- **CHARGING SYSTEM—HEADLAMPS, INSTRUMENT CLUSTER, RADIO OR INTERIOR LIGHTS FLICKER WHEN COLD—VEHICLES EQUIPPED WITH 2.5L ENGINE ONLY**
- **ELECTRICAL—HEADLAMPS, INSTRUMENT CLUSTER, RADIO OR INTERIOR LIGHTS FLICKER WHEN COLD—VEHICLES EQUIPPED WITH 2.5L ENGINE ONLY**

**Article No.
00-25-6**

MERCURY: 1999-2000 COUGAR

Figure 1 - Article 00-25-6

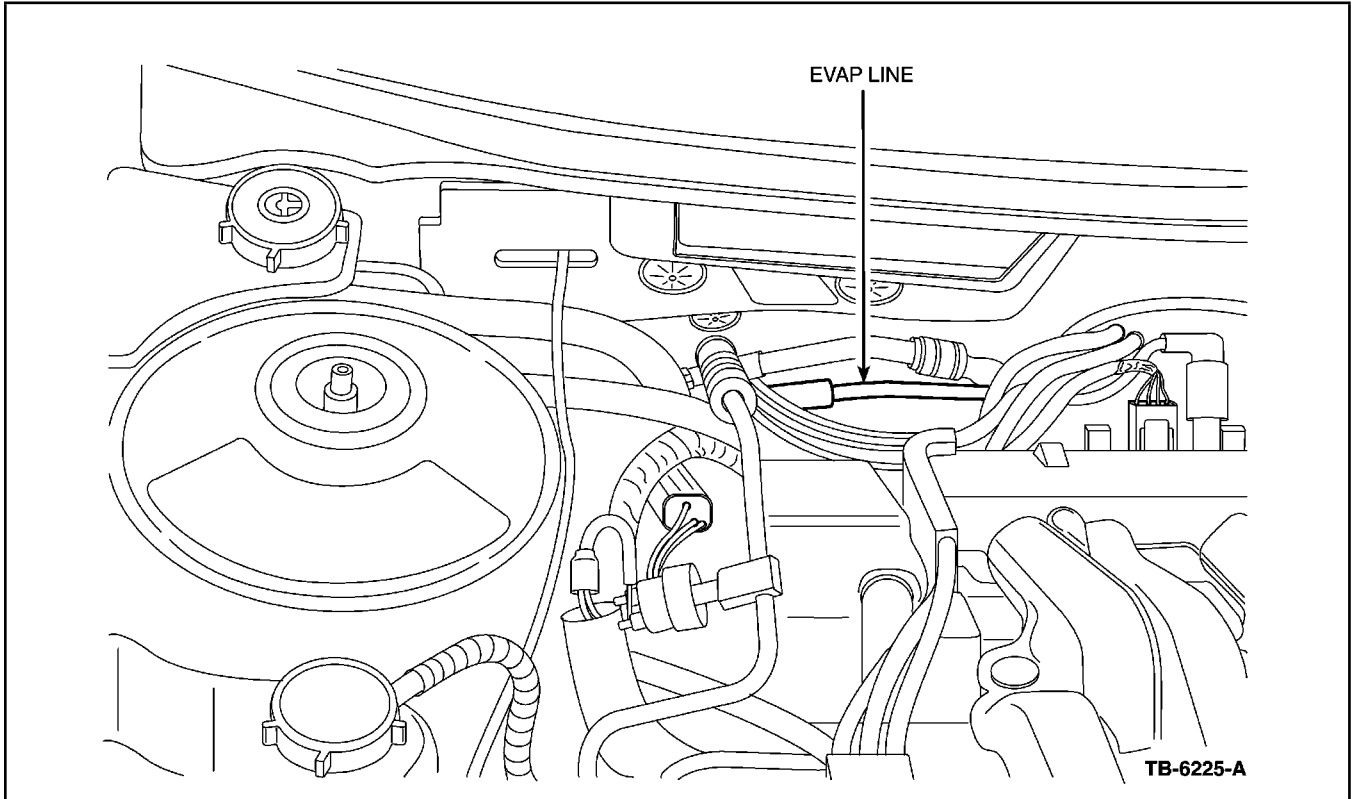
1. Verify condition.
2. Disconnect battery ground.
3. Disconnect EVAP emissions line at back of engine (Figure 1).
4. Remove battery voltage sensing/alternator fuse (circuit 30-BA8) from the engine compartment power distribution box (fuse 7 for vehicles built before 5/24/1999 and fuse 2 for vehicles built after 5/24/1999).

Figure 2 - Article 00-25-6

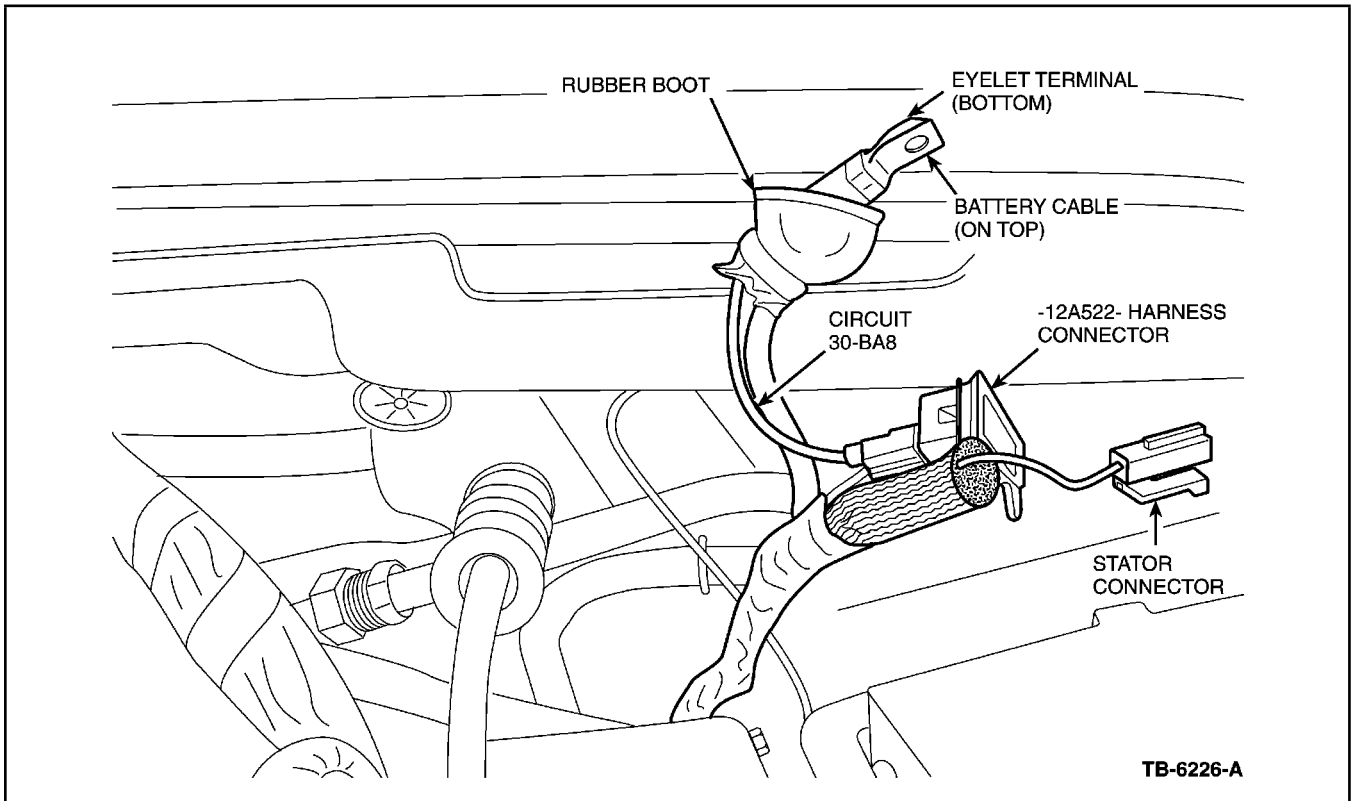
13. If L-shaped plastic shield is on the battery cable, untape and remove.
14. Slide eyelet terminal through rubber boot on battery cable such that the new terminal is on the bottom (Figure 2).

21. Connect battery cable and new terminal to B+ stud (new terminal on stud first) and torque nut to 8.0 ±1.2 N•m (70 ±10 lb-in).
22. Lower vehicle.
23. Connect battery ground cable.
